Powers/Hagerman/Corgroup  
10315 Allisonville Rd  
Fishers, IN 46038

## **Eastwood Middle School Addendum 5 11/16/18**

1. The geotechnical report dated 11/8/18 is attached.
2. Attached is an updated site logistics plan.
3. Specification Section
4. In Specification Section 011200 Multiple Contract Summary, Section 1.6 Temporary Facilities, delete paragraphs N and O and replace with the following.

4D WALL SECTION DETAILS 1 1/2" = 1'-0"

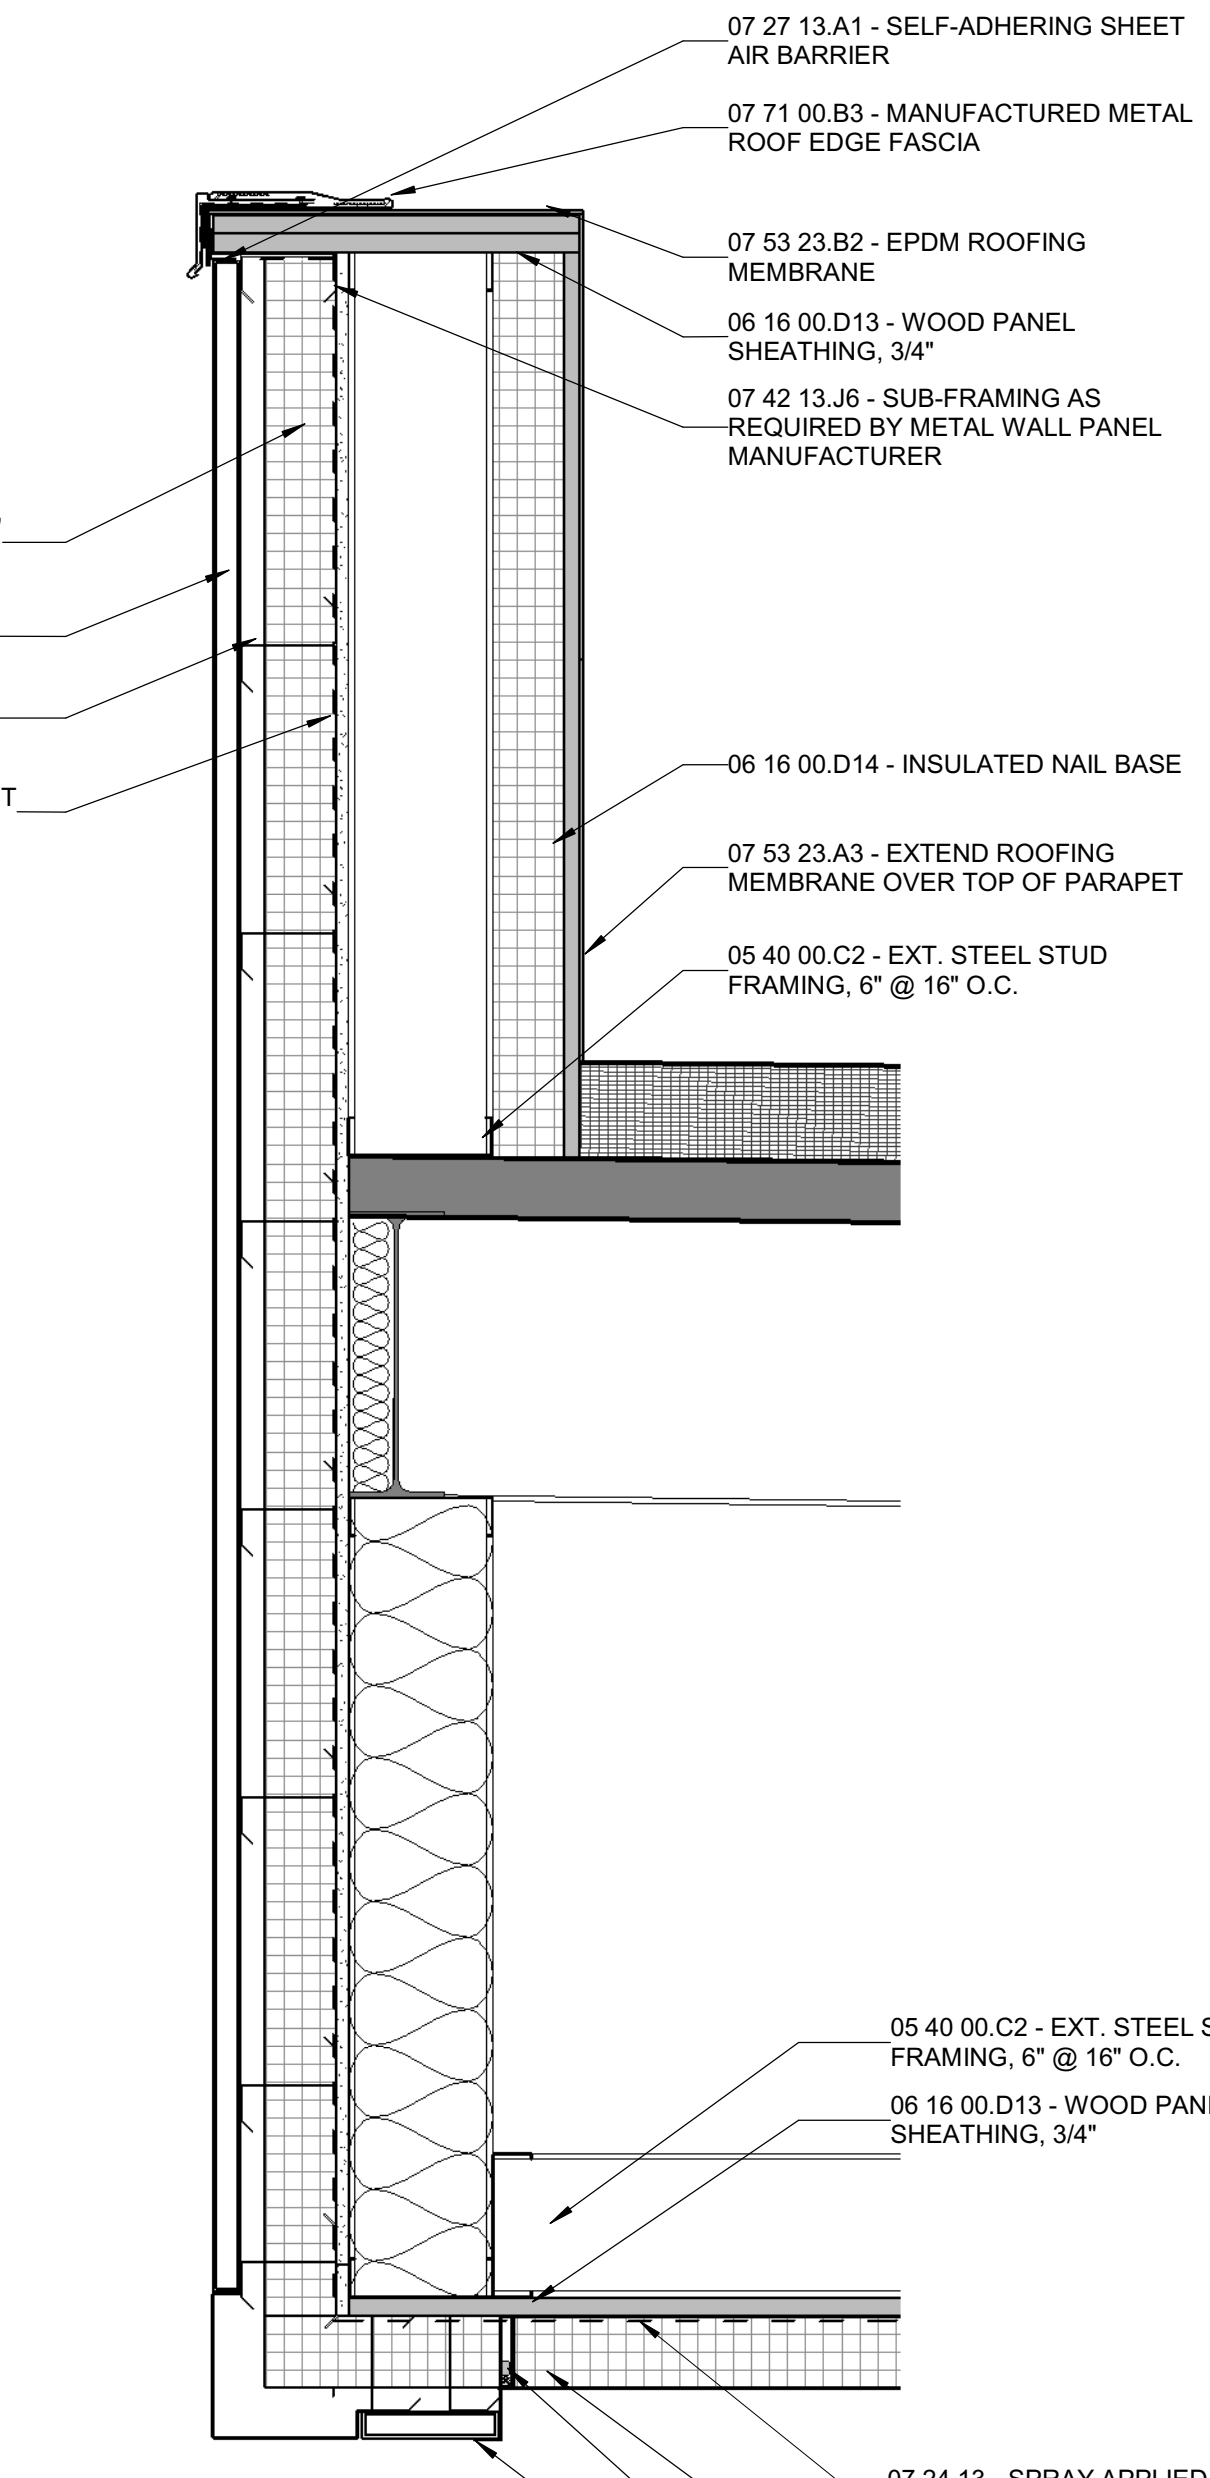
- N. **Drawing Number A-510**
  1. Detail 4D is a pocket for the Glass Partition.
    - a. Add opening for partition track, width as required per manufacturer.

- b. Add plastic laminate doors to enclose pocket, by partition manufacturer.
  2. Details 4D, 6C, 6B, 6A:
    - a. Revise to provide (S4iD) insulation around perimeter when operable partitions are closed.

**2A ENLARGED KITCHEN POWER PLAN**  
 1/4" = 1'-0"

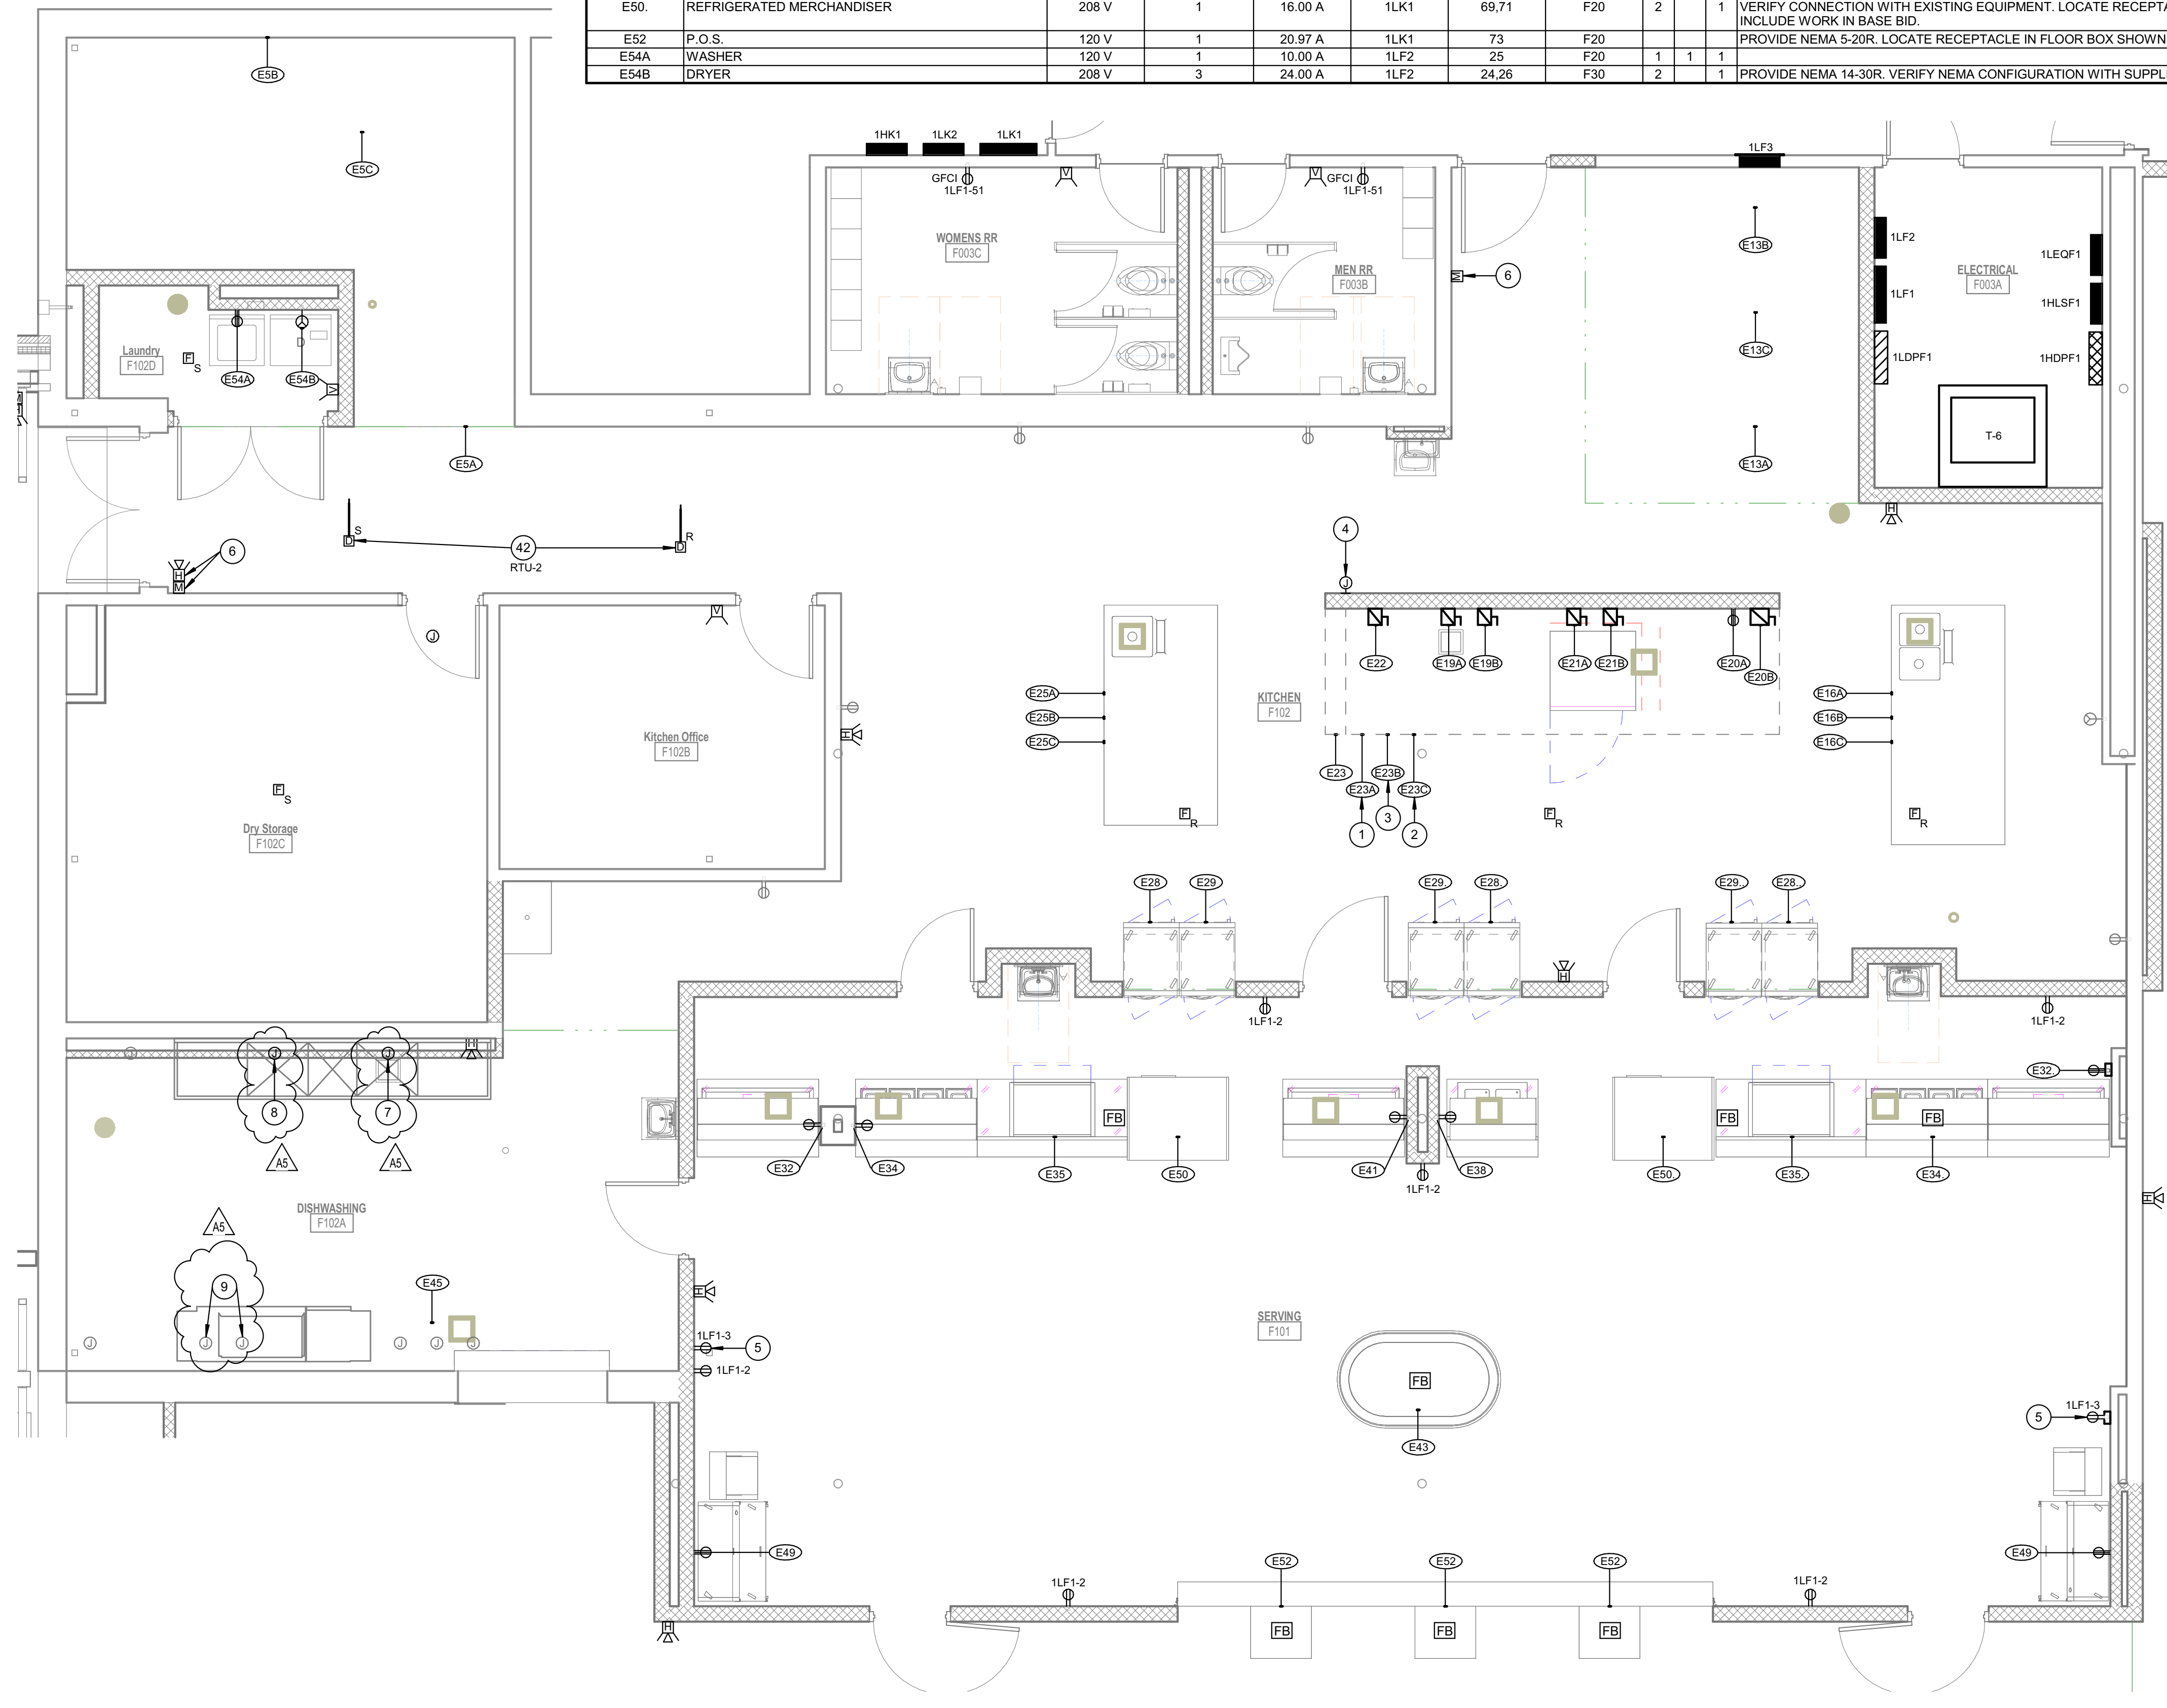
1. DELETE AND REPLACE Drawing E-403 in its entirety.
